Addendum No. 2

RFT 24-061 Gymnasium Addition - Glenview Public School

ADDENDUM #1

Project	Glenview PS Gym Addition	Project No.	2314
Location	143 Townsend Ave., Burlington, ON	Date of Issue	2024 05 17
Owner	Halton District School Board	File	2314/7.1.3

PARTIAL SITE PLAN - DEMOLITION

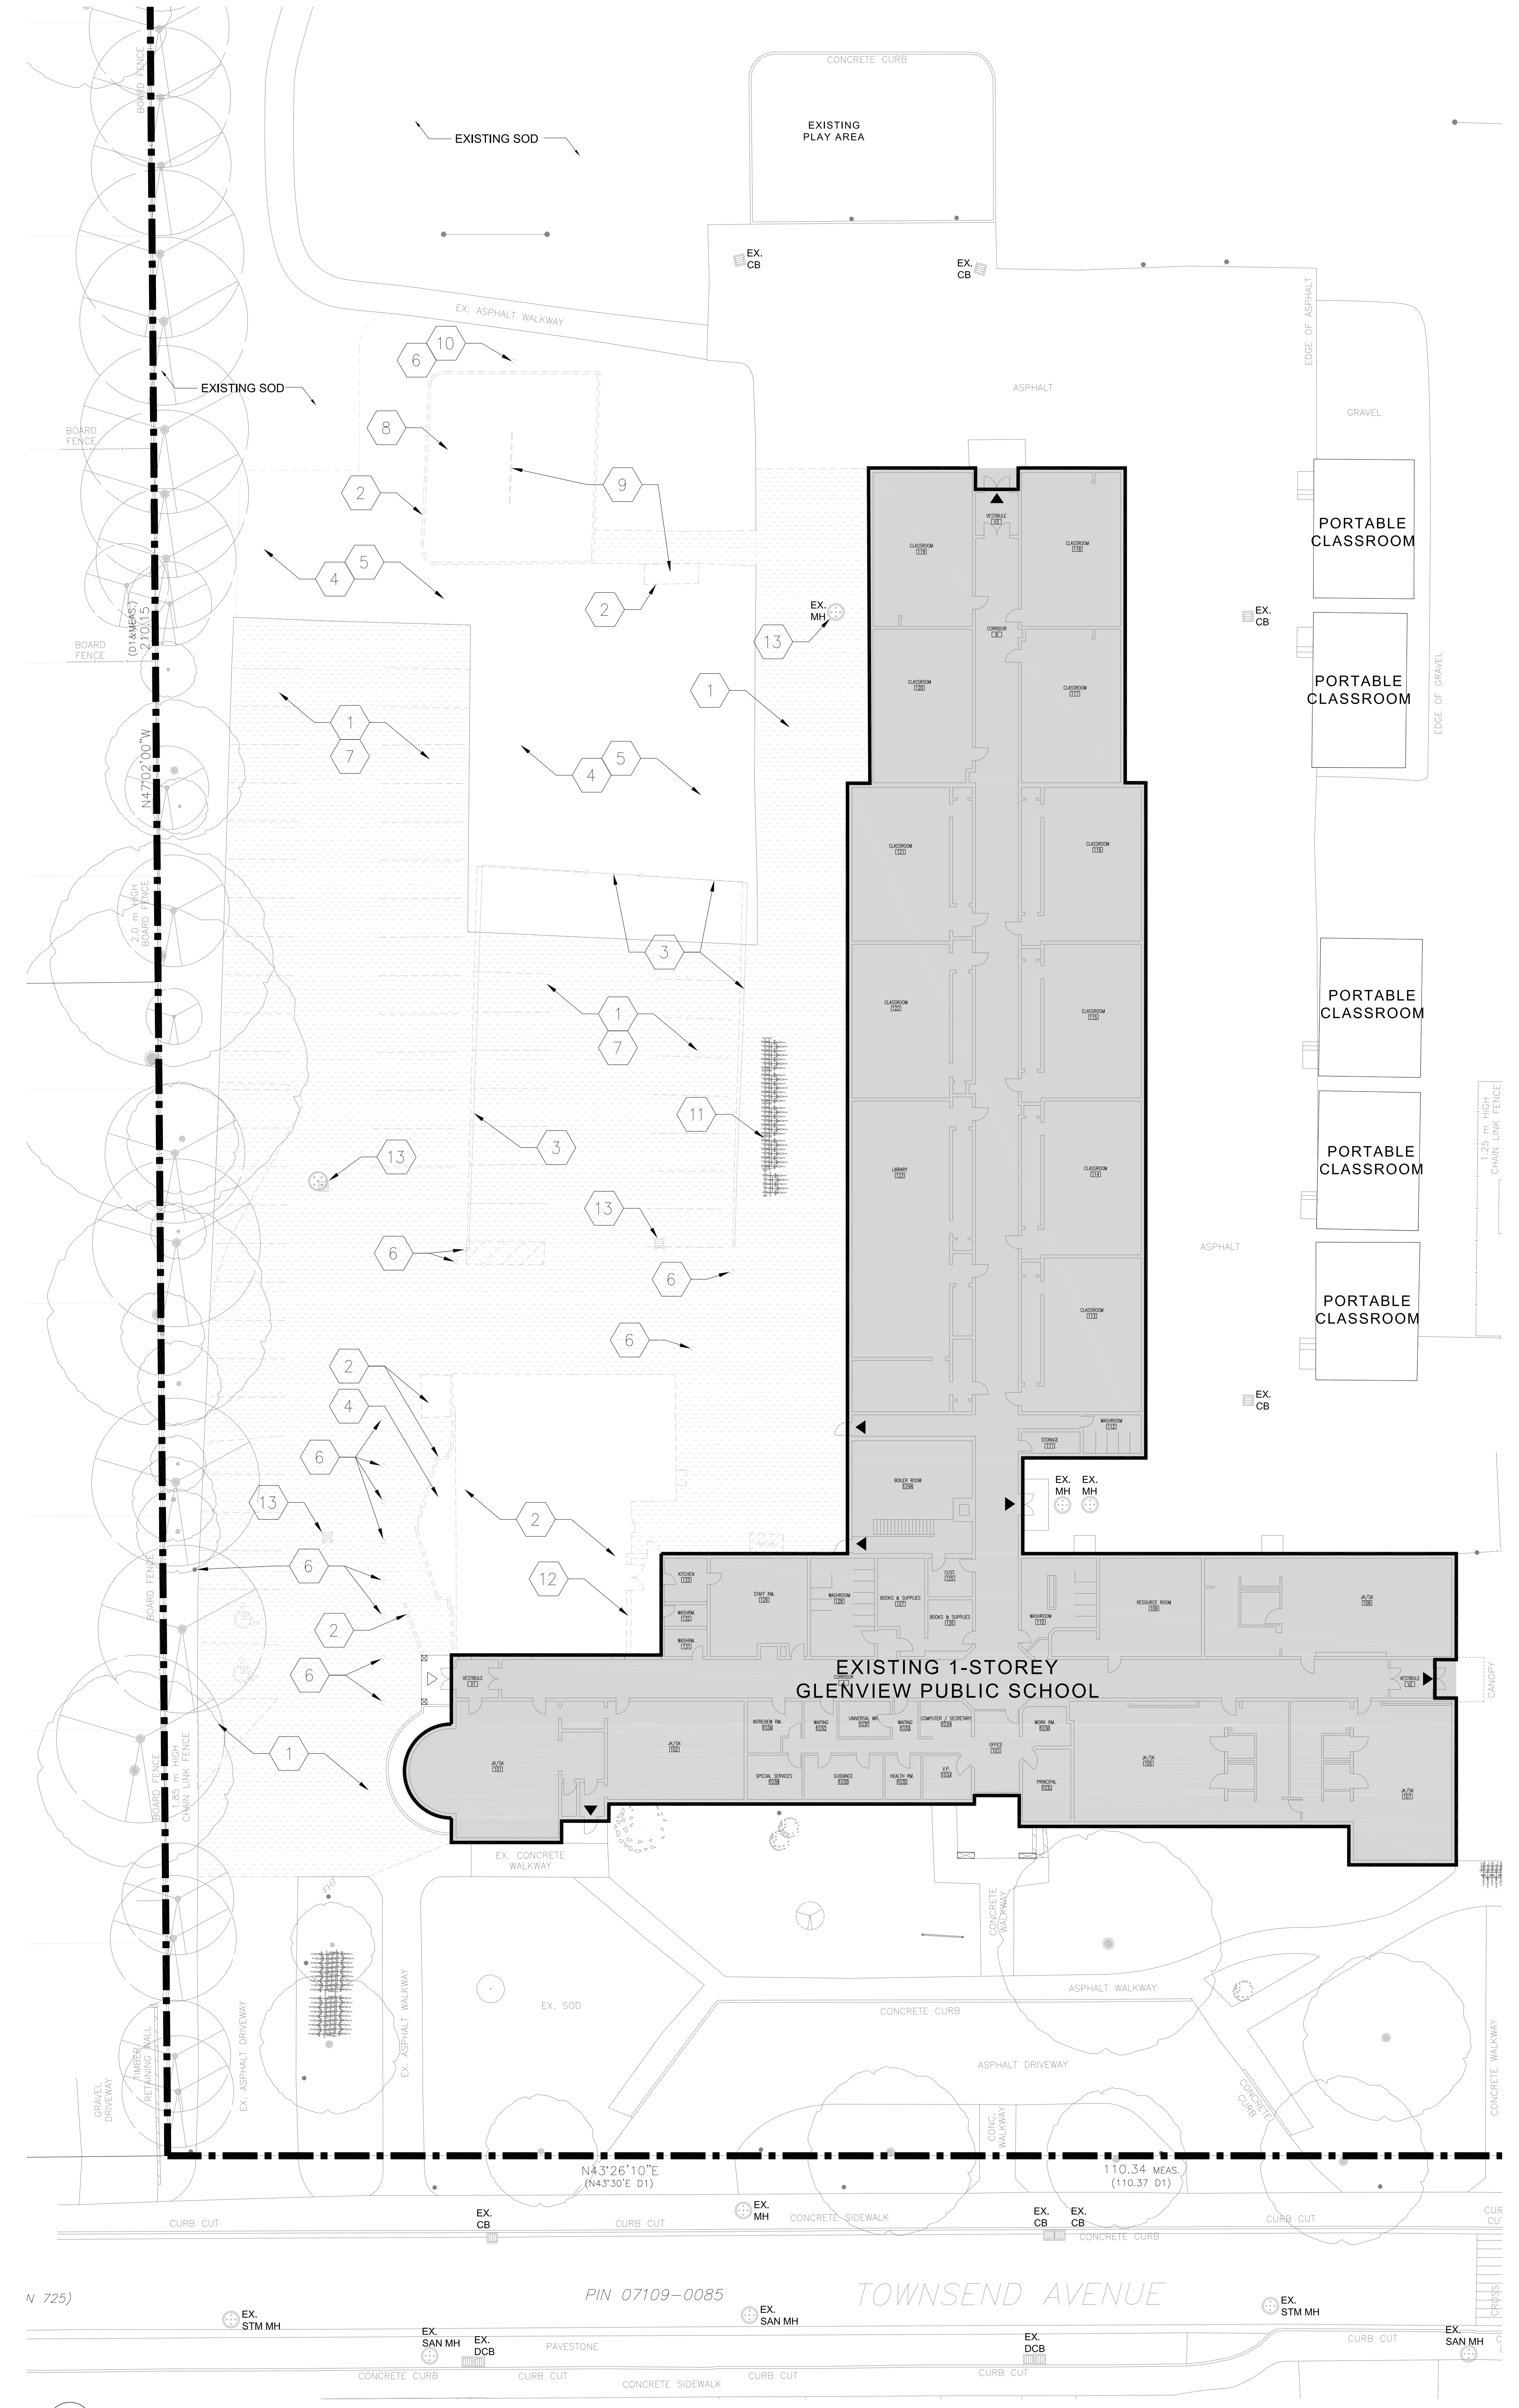
A1-2 DRAWING A103 PARTIAL SITE PLAN - DEMOLITION

- .1 Replace Drawing with the attached Revision No. 3.
- .2 Drawing reissued to include existing foundations and footings for demo Note 2. And to confirm depth of existing footings to be assumed as 1200mm below grade.

- SITE DEMOLITION NOTES**
- 1 REMOVE AND DISPOSE EXISTING ASPHALT PAVING INCLUDING BASE AND SUB-BASE AND PREPARE SUBSTRATE FOR NEW SURFACING.
 - 2 REMOVE AND DISPOSE EXISTING CONCRETE SLAB, FROST SLABS, CURBS, FOUNDATION WALLS AND FOOTINGS C/W ASSOCIATED SUB-BASE. PREPARE AFFECTED AREA TO RECEIVE NEW WORK. DEPTH OF EXISTING FOOTINGS TO BE ASSURED AS 1200mm (4') BELOW GRADE.

PARTIAL FLOOR & ROOF PLAN - DEMOLITION

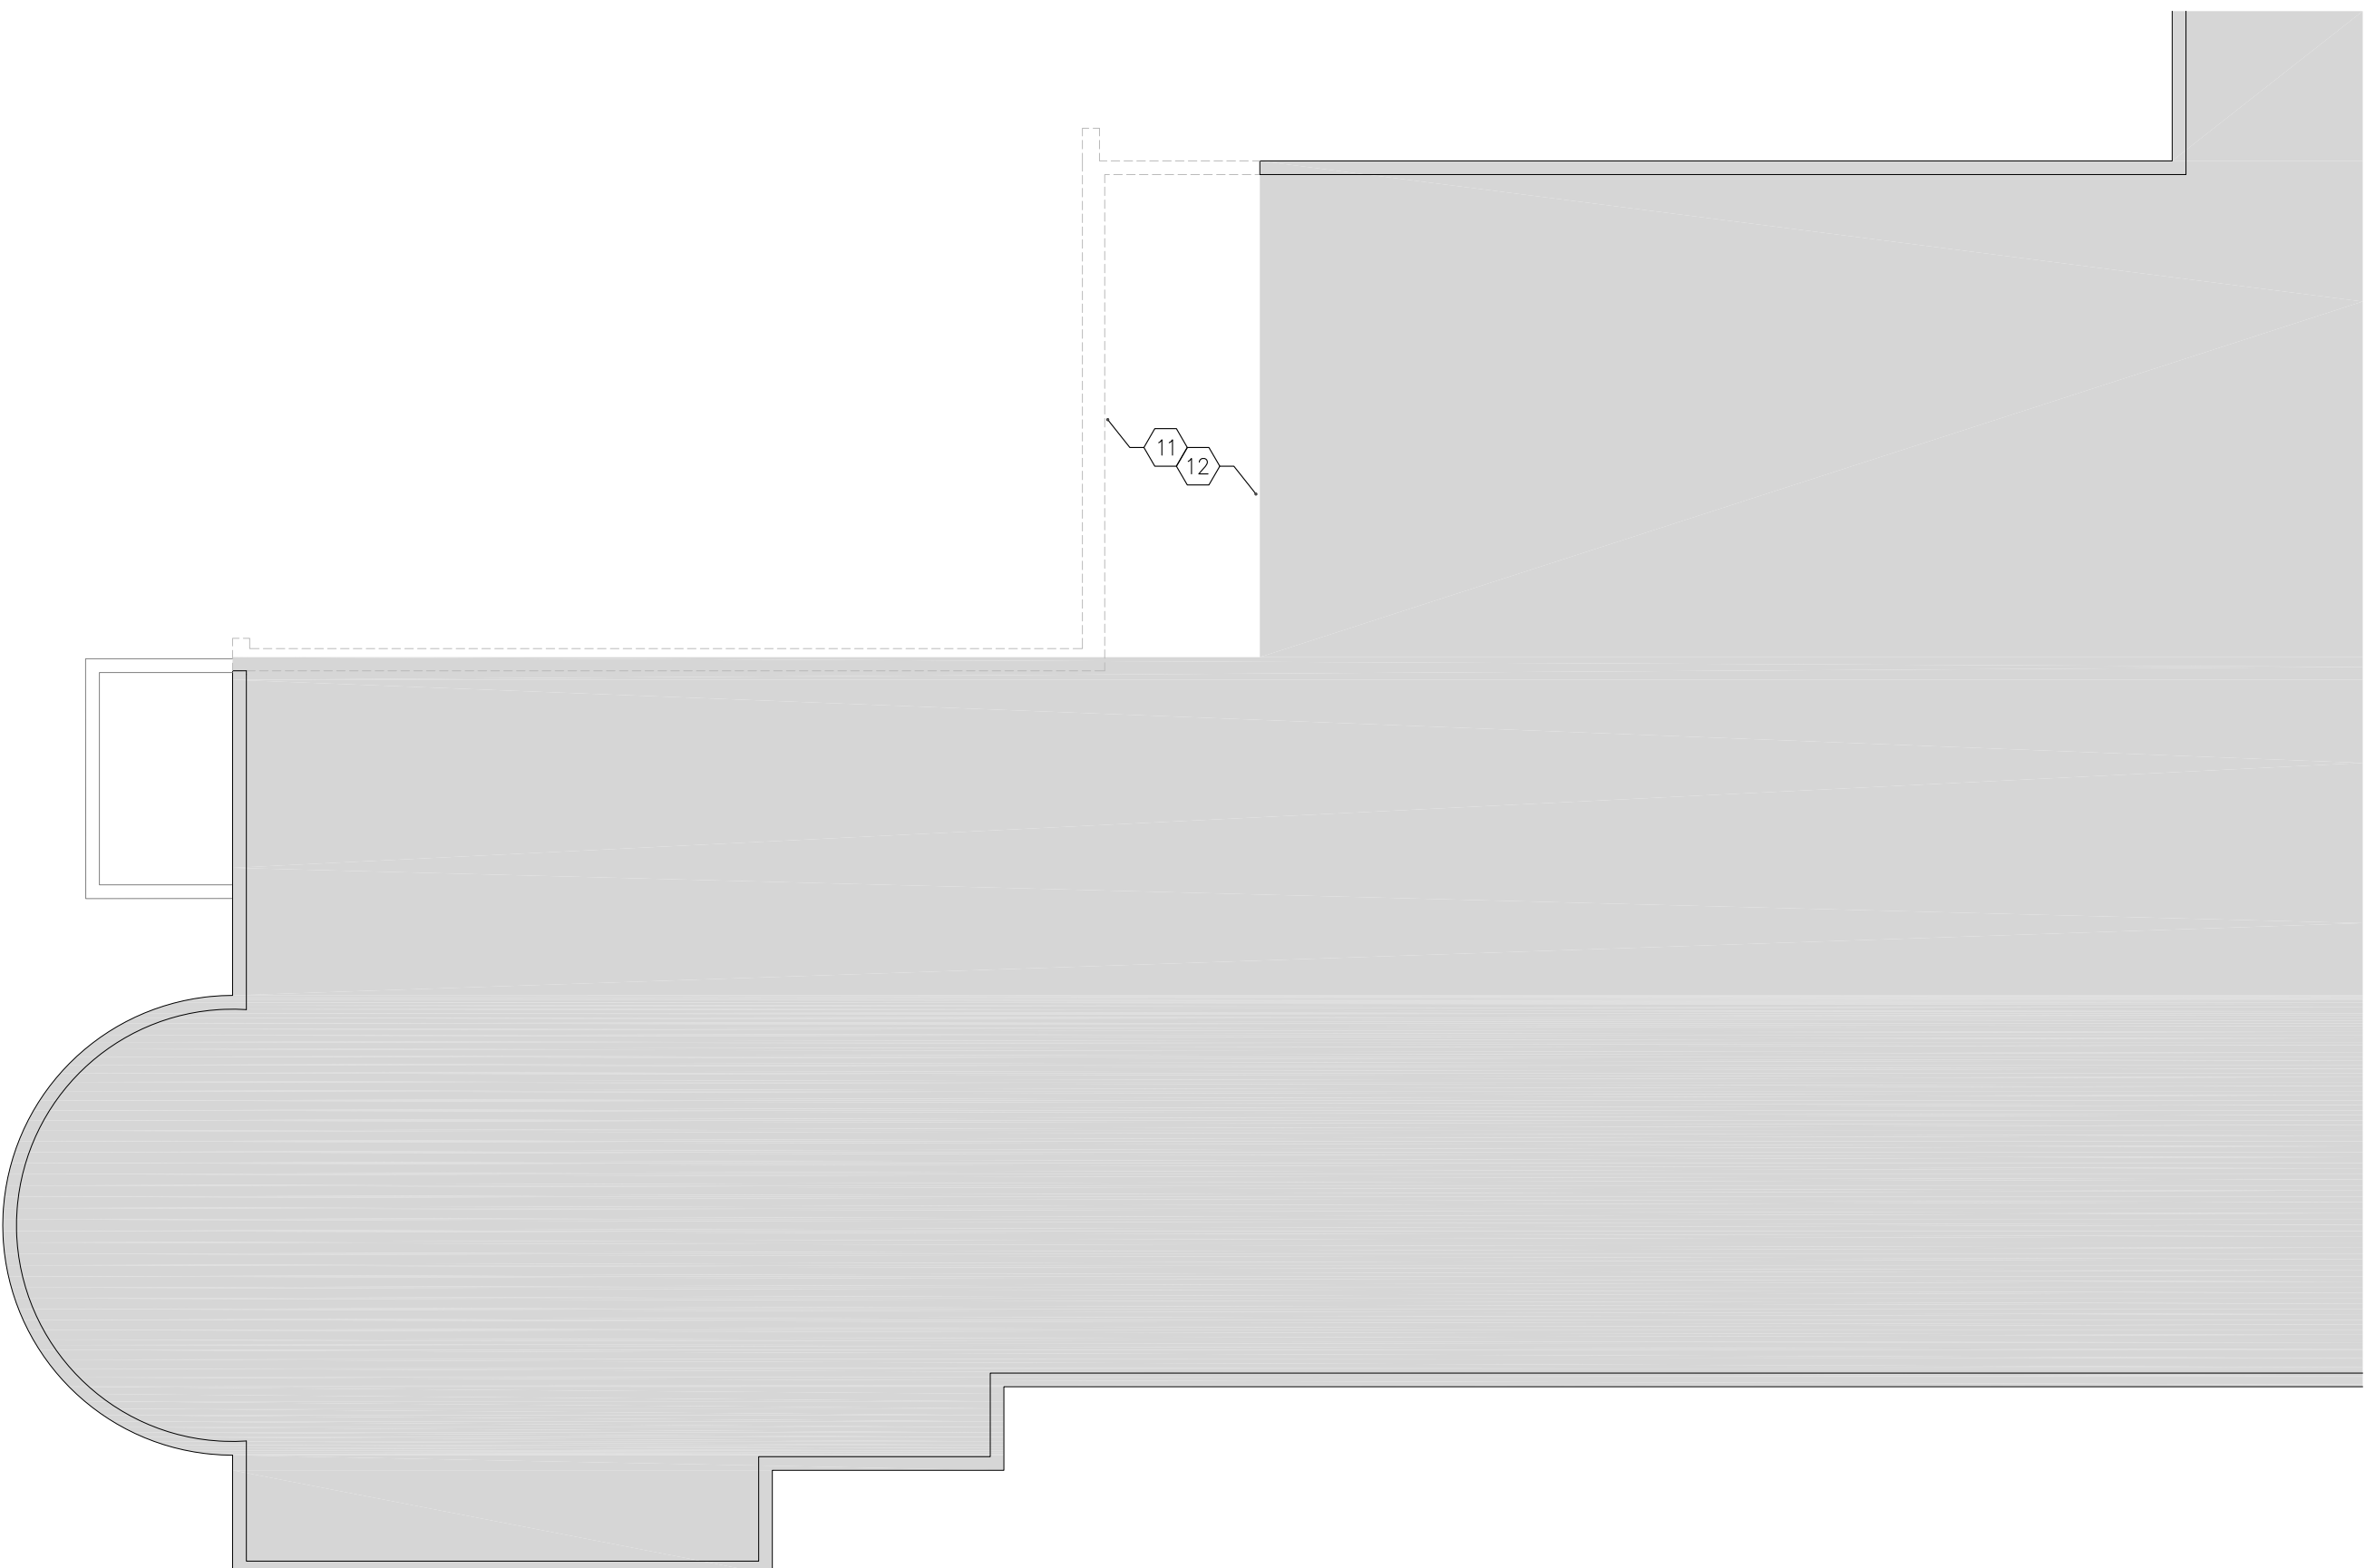
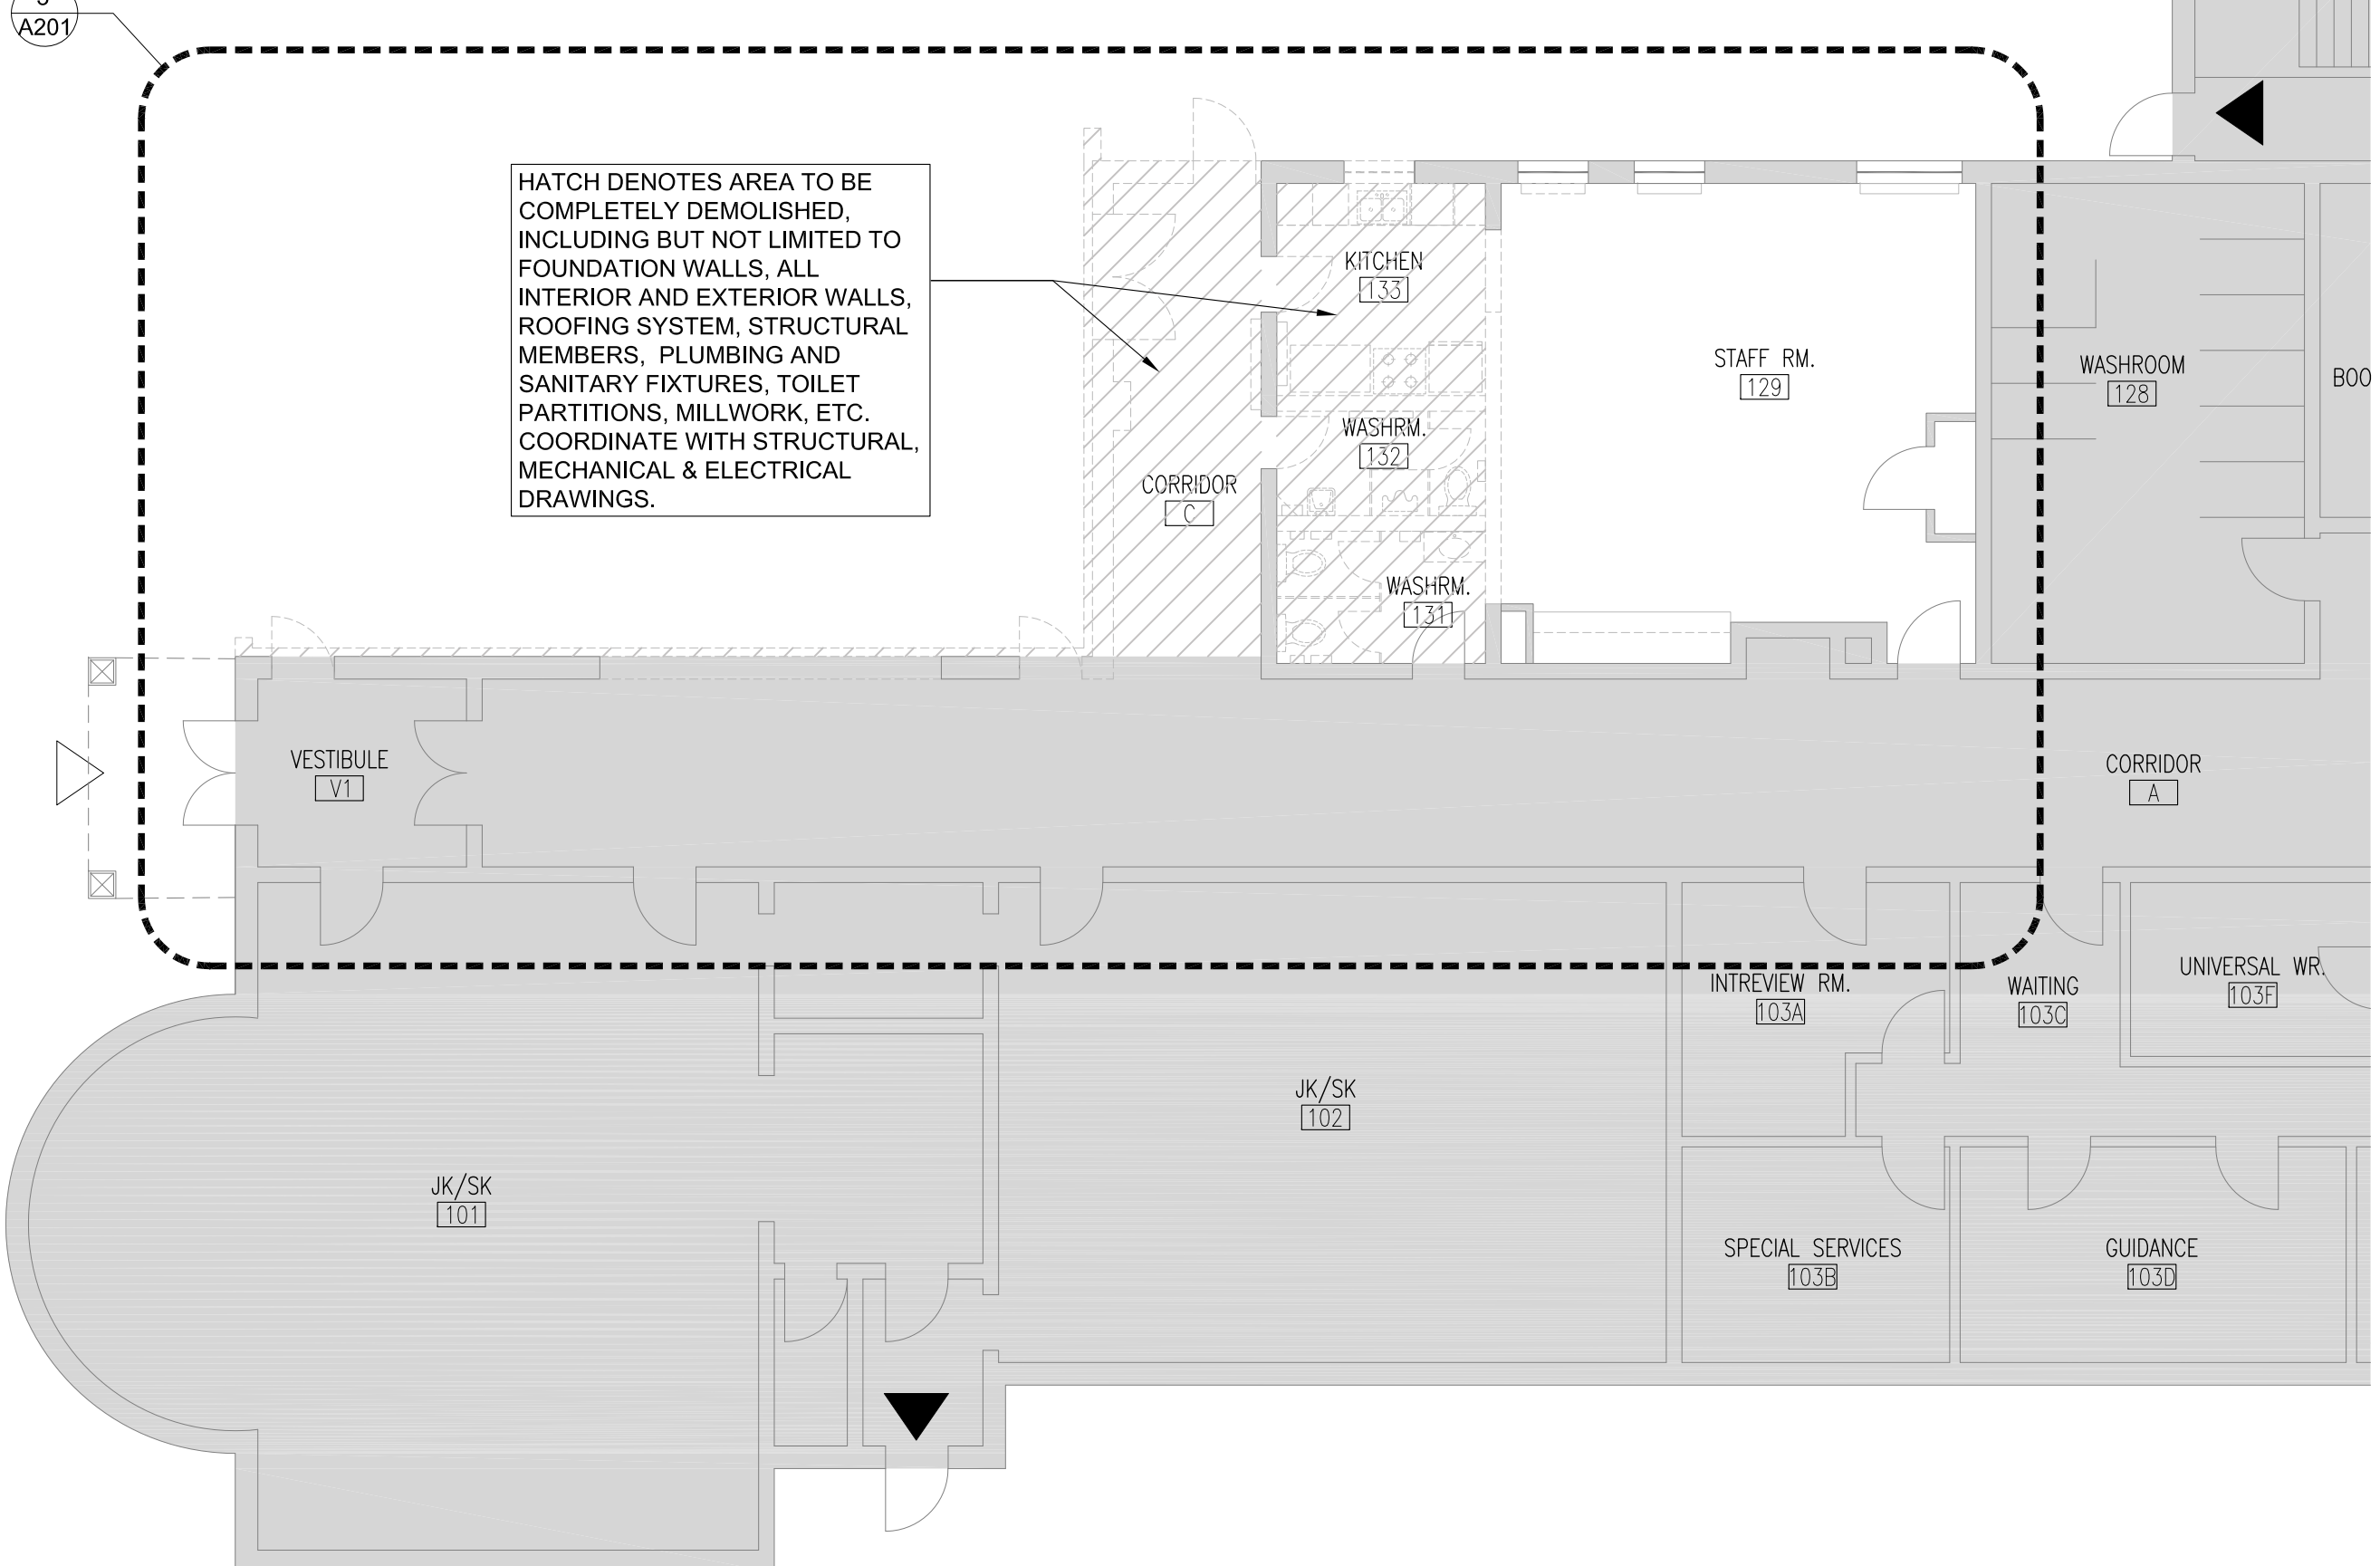
A1-3 DRAWING A201 PARTIAL FLOOR & ROOF PLAN - DEMOLITION

- .1 Replace Drawing with the attached Revision No. 3.
- .2 Drawing reissued to read room names clearly for 1/A201 and 3/A201.
